## Report to Development Permit Panel

**To:** Development Permit Panel  
**From:** Jean Lamontagne  
Director of Development  
**Date:** March 5, 2007  
**File:** DP 05-312751  
**Re:** **Application by Patrick Cotter Architect Inc. for a Development Permit at  
8400 and 8440 Anderson Road**

That a Development Permit be issued which would permit the construction of 43 apartment units over a parking level at 8400 and 8440 Anderson Road on a site zoned "Comprehensive Development District (CD/170)".

### **Appendix –3: Tree Protection Fencing Detail**

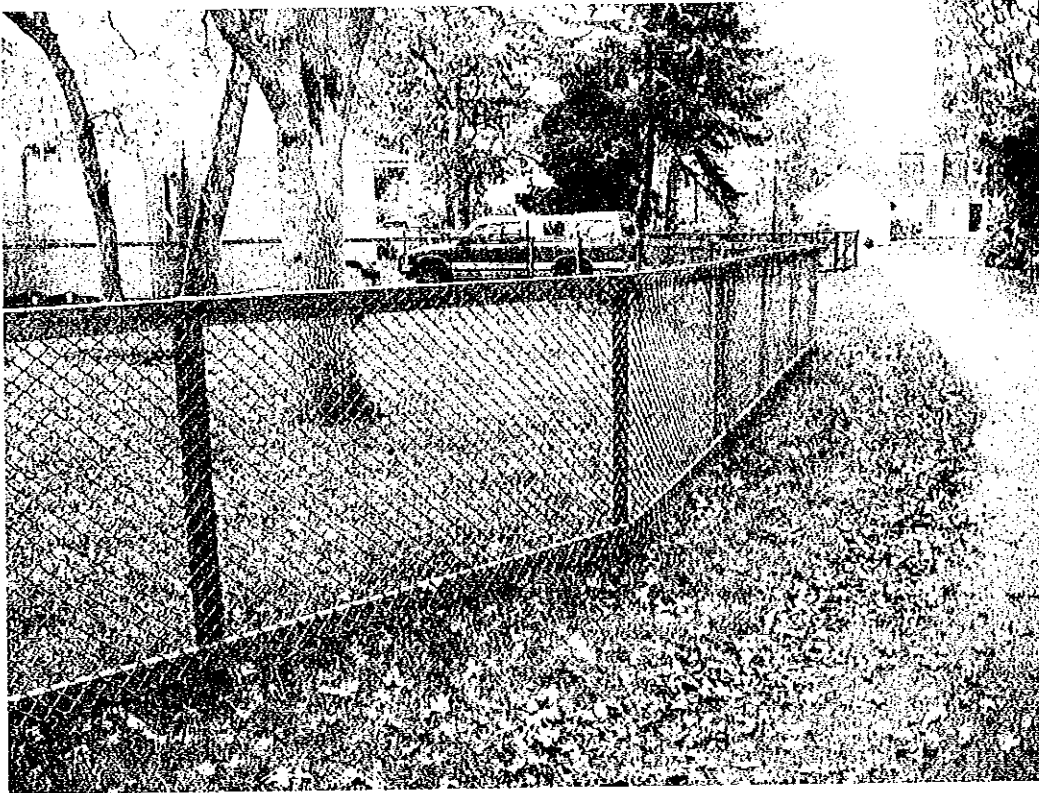
We recommend that protective fencing be erected parallel to the retaining wall at an offset distance of .5 meters toward the tree and terminating at the property lines on the east and south sides of the site. A detail of the protection fencing is attached. No other special measures are required to protect this tree, beyond periodic monitoring to ensure that the fencing remains in place.

Robust Tree Protection Fencing shall be constructed with a 2x4 frame and supports. (See photo below.) Snow-fencing will then be affixed to the frame using zip-ties, staples wire or nails. All-weather signage will be attached, clearly designating the area within as a TREE PROTECTION AREA – NO TRESPASSING.

(1) SIGN ELEVATION  
 (A) 11/15/07

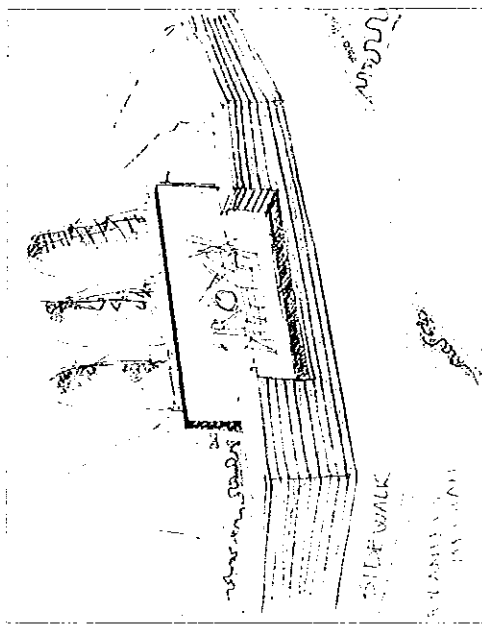
- the southwest corner, where it steps back, doesn't look quite right and may be a surface issue;  
**We addressed this issue by redesigning that area, we added a site identification sign, reference A-304 and we used multiple architectural elements, including trellis, columns, materials and finishes.**

- roof play structure might not be appropriate;  
**Play space required**
- there can be a design development on the southwest corner;  
**We added a site identification sign reference A-304 and we used multiple architectural elements: trills, columns, materials and finishes.**
- consider extending the thin top roof further to provide covered outdoor amenity space;  
**A canopy covering part of the upper roof deck is provided for materials and colors reference A-303.**
- design development to parking entry and pedestrian entry; consider extending “canopy” over the entry.  
**We addressed this issue by redesigning the entrance area and by adding multiple architectural elements: trellis, columns, finishes. We extended the canopy over the entry.**
